Submissions in response to SSD-10421 WEIGALL SPORTS COMPLEX, SYDNEY GRAMMAR SCHOOL

NAME – Margaret Shearer

DATE – 16 December 2020

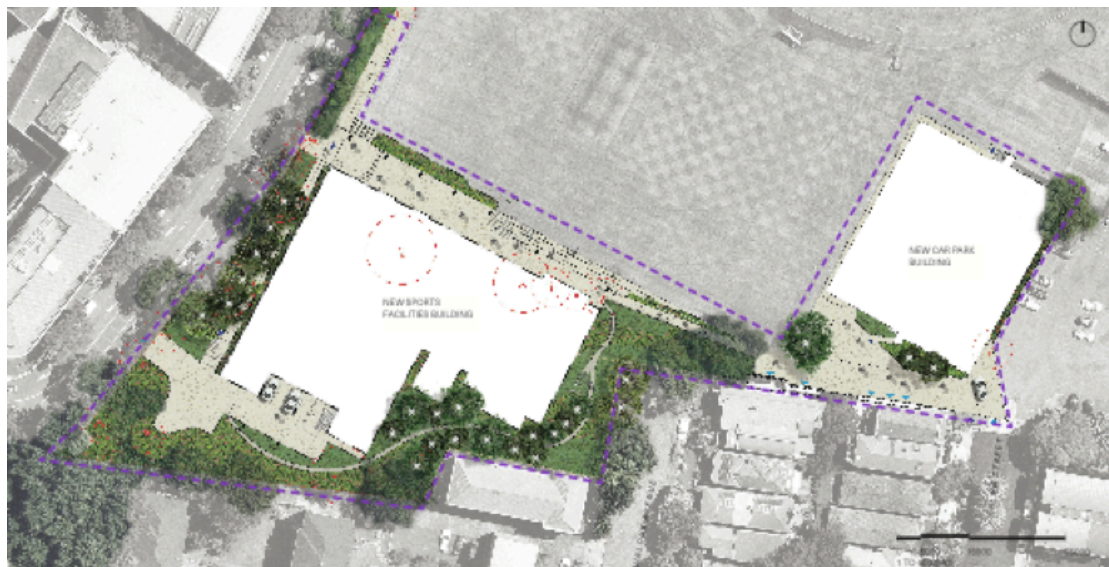
As an example of how information was not sufficient to allow consideration or provide consultation, a look at the information on the tree removal plan is illustrative.

At the first consultation evening in around June, Margaret Shearer was advised that only a “few scruffy trees” were to be removed and that all efforts were being made to retain others.

Weigall Sports Complex Landscape Plan

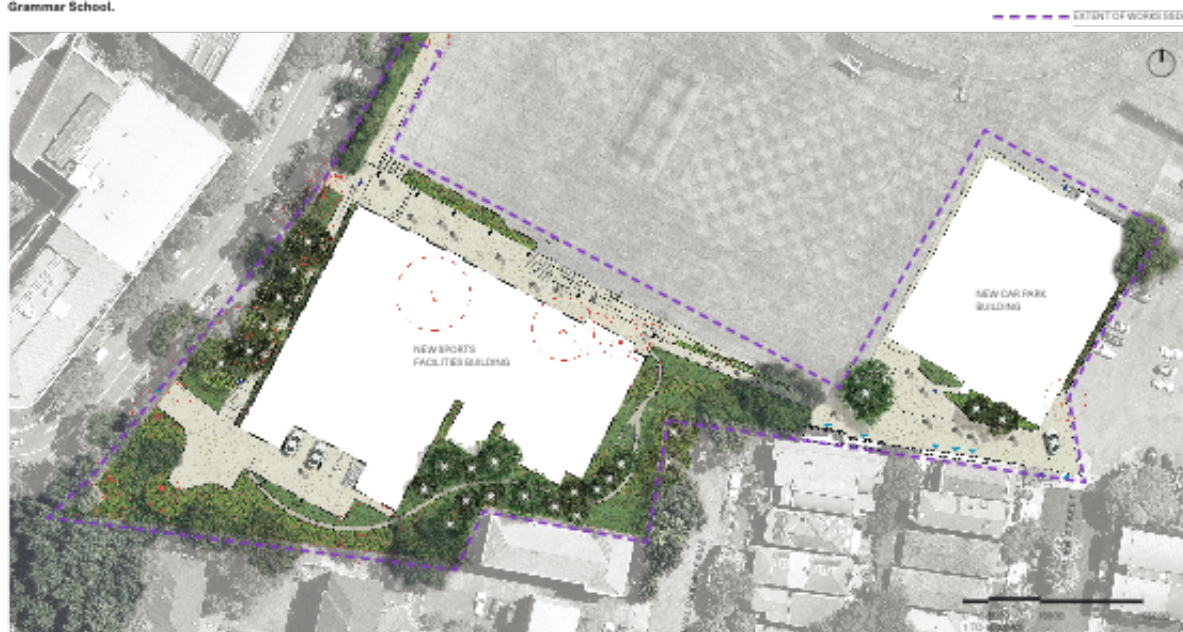
So that we can consider the current thinking fully can you please send an electronic copy of the plans that were shown to us last night. To be clear, I am not talking about the display boards (where there is little detail and where some important details were covered by text) but the multi paged detailed plans that were shown to us by Leigh.

I've attached the draft landscape plan that was contained in the A3 booklet.

As you note below, the plans that were shown in the rest of that folder are WIP documents and are in the process of being finalised by the team.
